La Marzocco Technical Bulletin #110

New Vulcano Hoppers

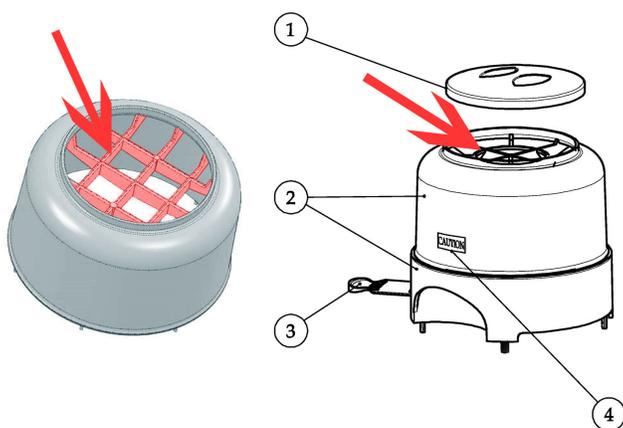
The shape of the inlet hole has been modified to facilitate easier loading of coffee. The new grid (shown on left) is positioned a step below the rim unlike the previous design (shown on right) and includes the same geometry as that of the Vulcano Swift hopper.

The new spare part is already available for order through the Parts Department, with the unmodified code M.1.004

We introduced the new hopper on Vulcano On-Demand and Vulcano Automatic starting from SN1431544.
